WILLIAMSON COUNTY, TEXAS

CHANGE ORDER NUMBER: 6

Project:	<u>Great Oaks Dr. Improvements</u>
Roadway:	<u>Great Oaks Dr. @ Brushy Creek</u>
CSJ Number:	<u>T4327</u>

Change Order No.6

RETAINING WALL LAYOUT
WALL RW-1A

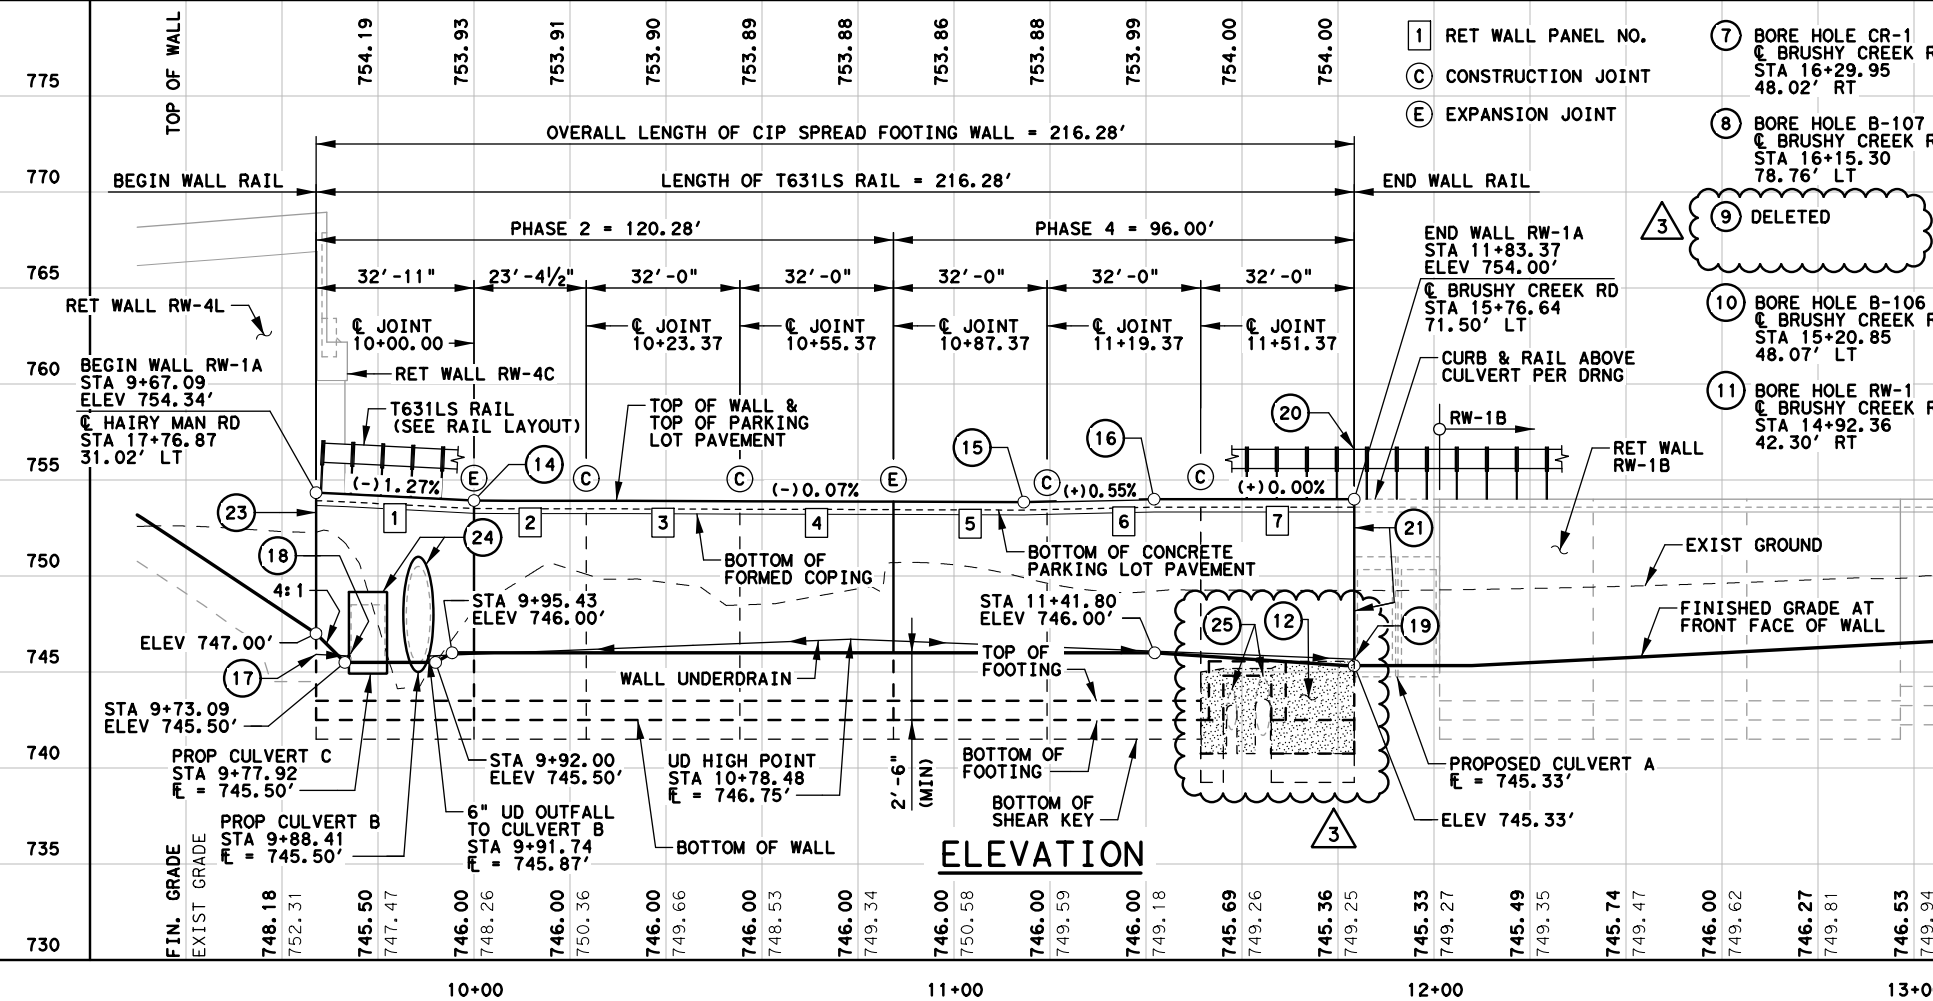
3 REV-3 CONSISTS OF
MODIFIED DETAILS FOR
CIP RETAINING WALL
RW-1A, WALL PANEL NO. 7.

25 SEE WALL NOTCH DETAILS FOR
SPECIAL WALL GEOMETRY &
REINFORCEMENT AT EXISTING
WATER LINES

12 AFTER FOOTING & WALL HAVE BEEN
CAST, PLACE SELF-CONSOLIDATING
FLOWABLE BACKFILL PER SPEC ITEM 401
FROM BOTTOM OF EXCAVATION IN FRONT
OF AND BEHIND WALL PANEL NO. 7
FOOTING & WALL. BRING FLOWABLE FILL
MATERIAL UP TO TOP OF PIPE CASING
AND TO UNDERSIDE OF UNDERDRAIN.

RETAINING WALL LAYOUT
WALL RW-1A

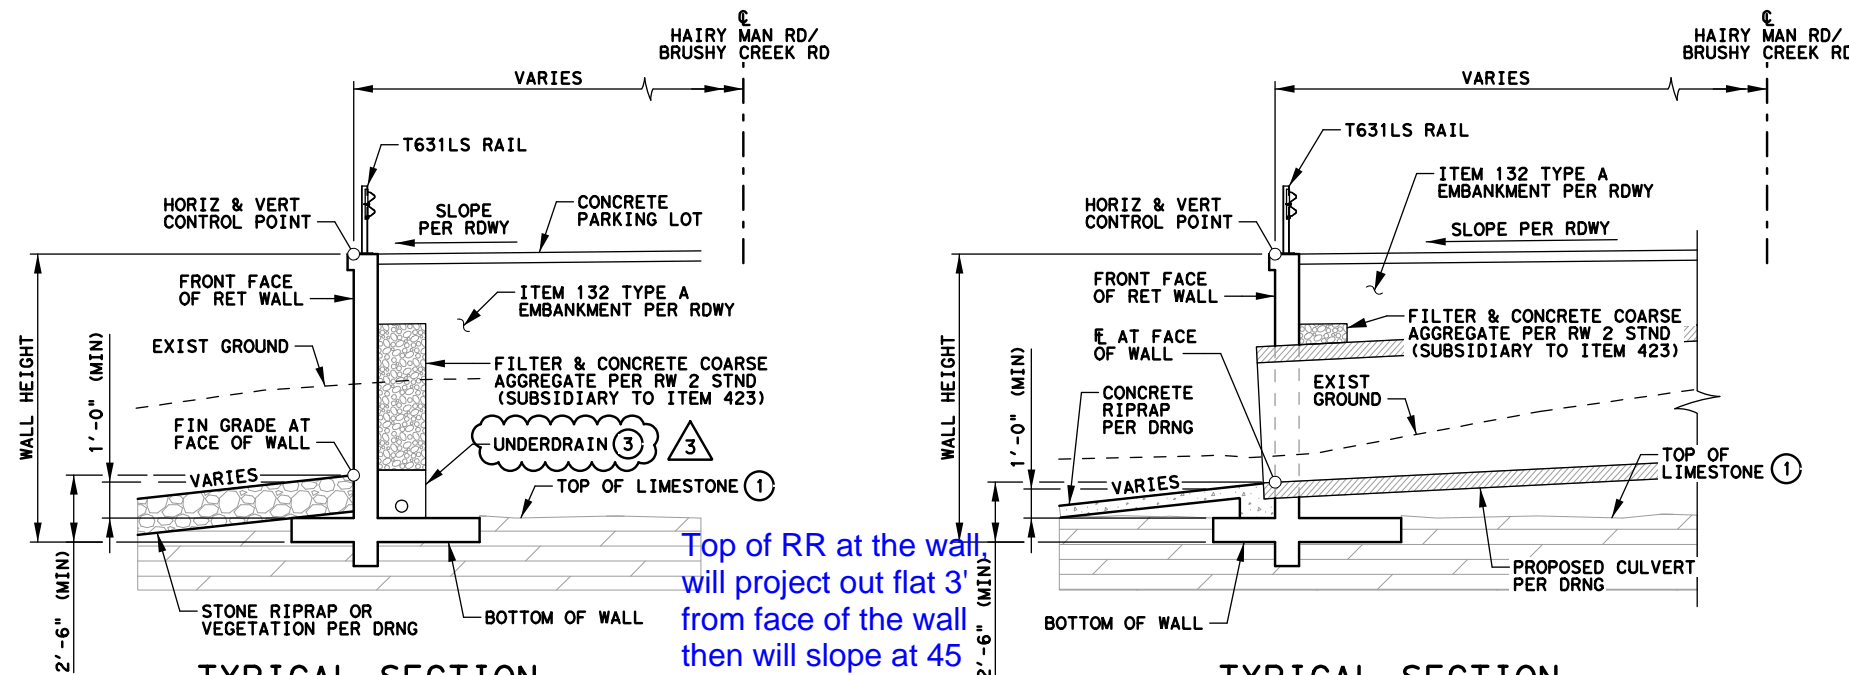
REV-3 CONSISTS OF MODIFIED DETAILS FOR CIP RETAINING WALL RW-1A, WALL PANEL NO. 7.

2 SEE SHEET 266B FOR RW-1A PANEL No. 7 DESIGN DATA.

SEE SHEET 266A FOR WALL NOTCH DETAILS WITH ADDITIONAL REINFORCEMENT REQUIREMENTS, DIMENSIONS, NOTES AND OTHER INFORMATION.

RETAINING WALL DETAILS
WALL RW1-A PANEL NO.7
WALL & FOOTING DETAILS
AT EXISTING WATER PIPE

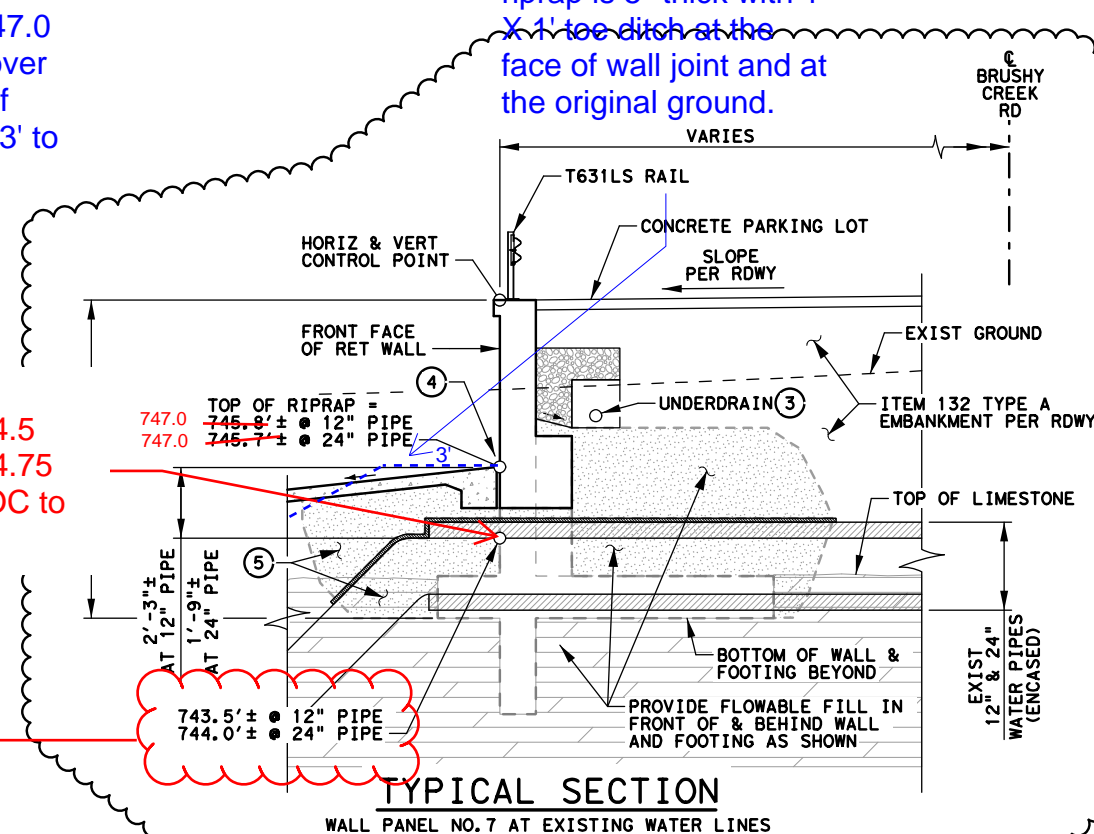
The proposed 747.0 elevation gives over 2' cover on top of casing and over 3' to top of pipe -- (flowable fill + concrete riprap)

If elevations are top of pipe
top 24" casing for 12" = 744.5
top 42" casing for 24" = 744.75
This means only 1' from TOC to top of RR at 42" casing

confirm whether these elevations are top of pipe (as they appear to be drawn) or top of casing

These elevations are top of pipe

RETAINING WALL DETAILS
WALL RW1-A PANEL NO. 7
WALL & FOOTING
DETAILS

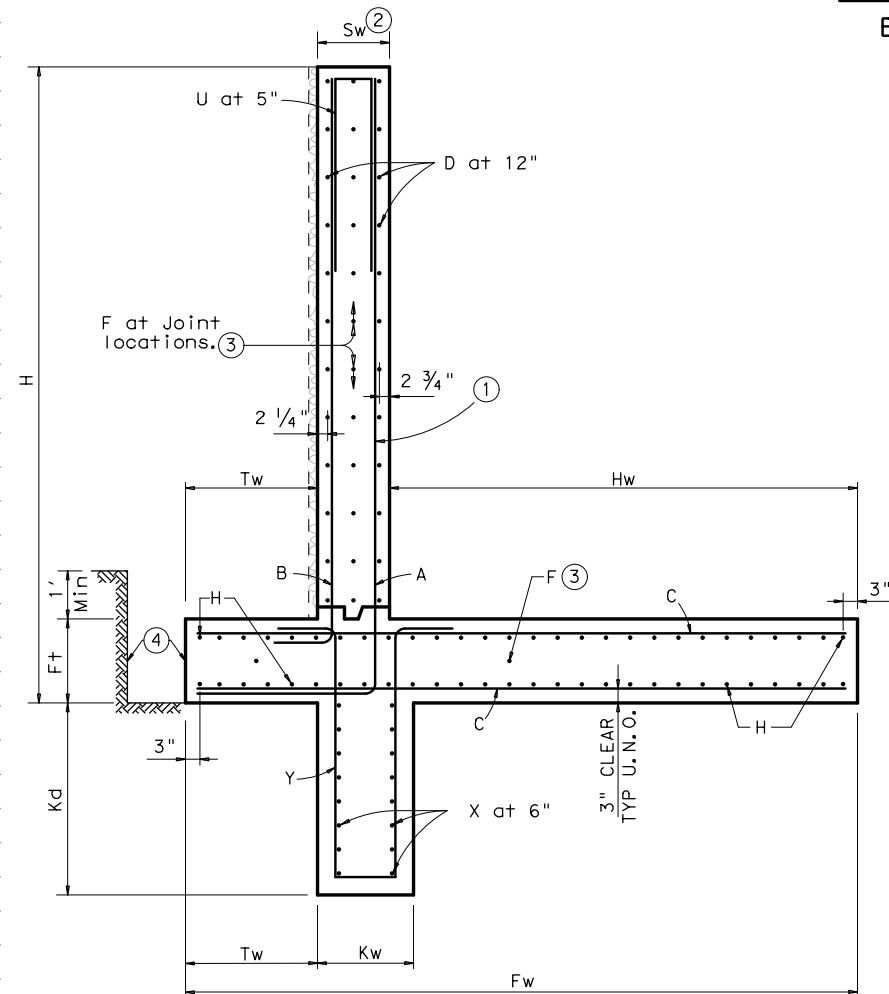
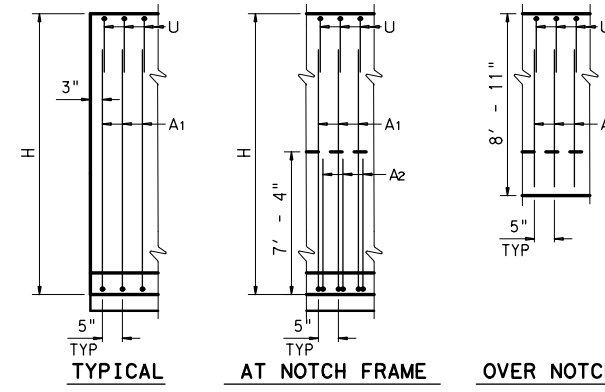
- ⑤ Space Vertical S Stirrups at 10" c-c, and space Horizontal S Ties at 6" c-c. See Notch Details for additional information.

- ⑥ Reduce horizontal leg length where shown on Sheet 266A Enlarged Plan View.

REV-1 CONSISTS OF MODIFIED DETAILS FOR CIP RETAINING WALL RW-1A, WALL PANEL NO. 7.
